WASTE ISOLATION PILOT PLANT

SPALLINGS

PEER REVIEW REPORT

October 2003

Figure 3-3: Failure and Fluidization

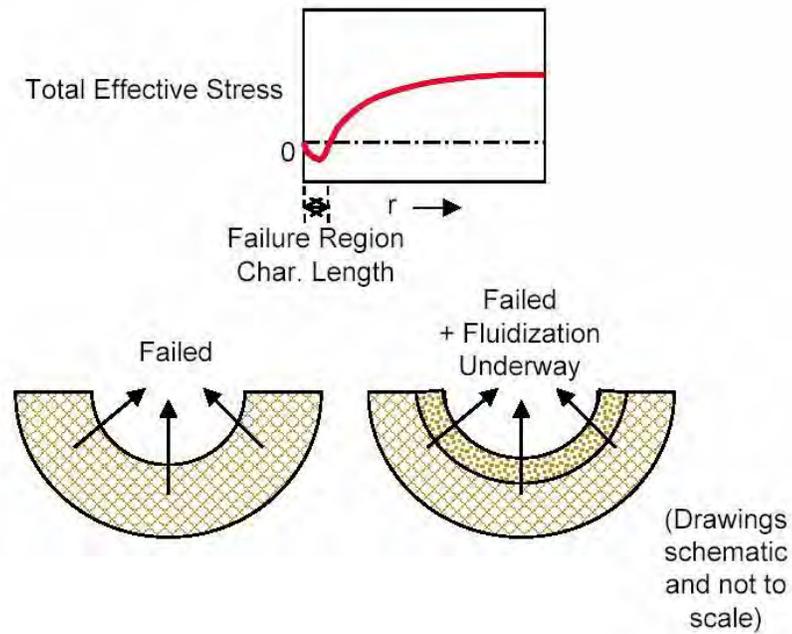
In the numerical implementation, a characteristic length L_c , that covers several grids (or nodal points) is used to determine the failure zone of the medium. Note that L_{fz} shown in Figure 3.3 is the length of tensile failure zone which may consist of several characteristic lengths. When the average effective radial tensile stress over the characteristic length exceeds the failure stress T_o , the particles inside the length are assumed failed. Therefore, the failure zone shown in Fig. 3.3 may contain several characteristic lengths. The characteristic length is an important parameter in determining the size of failure zone and the volume of spalling release. The effect of characteristic length on spalling volume will be discussed in a later section.

There are three important parameters in this section: the tensile strength of the waste, T_0 ; the critical flow velocity for waste fluidization, U_f ; and the critical length for calculating the failure zone, L_c . In addition, there is an assumption of a perfect-gas law for the gas-particle mixture. The tensile strength of the waste matrix, T_0 and the critical flow velocity for fluidization, U_f are determined from experimental studies. The Panel has no reason to doubt their validity. The effect of critical length L_c and tensile failure strength T_0 on the final results can be assessed from a sensitivity study. However, the use of a perfect-gas law for the gas-particle mixture is entirely dependent on one's judgment. The significance and the effect of this assumption on the final results is difficult to determine from a sensitivity study. The assumption appears to be reasonable and would yield a conservative waste release prediction.

Figure 3-4: DDZ in front of the drill bit

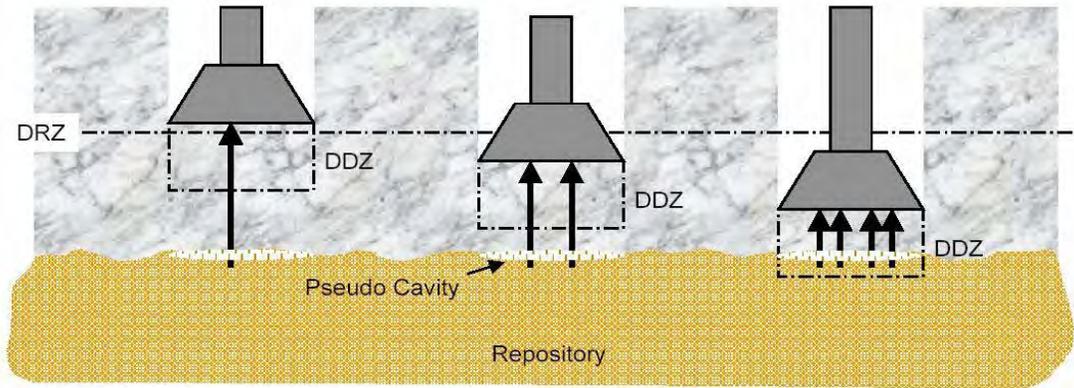
Although the DDZ is not mentioned in SAND97-1369, it was presented during the peer review. As mentioned in a previous section, it has been assumed that the action of the drill bit produces a damaged zone (DDZ) in front of the advancing bit. The DDZ serves as a transition zone between the borehole and the repository. It allows the gas pressure at the bottom of the mud column to buildup smoothly reaching the reservoir value (i.e., no pressure discontinuity as the bit penetrates through the interface). In the numerical calculation, a small air cavity is placed at the interface of mud and repository to ensure the continuity condition between these two regions.

The DDZ is assumed to have a higher permeability than the host rock (halite) and the DRZ (Damaged Rock Zone) but a lower permeability than the repository. As the drilling bit approaches the interface between the host rock and the repository, the lower boundary of the DDZ will contact the repository first. At this time, the gas trapped in the repository would flow upward through the DDZ and interact with the mud column. Figure 3.4 shows drilling damaged zone in front of the bit.
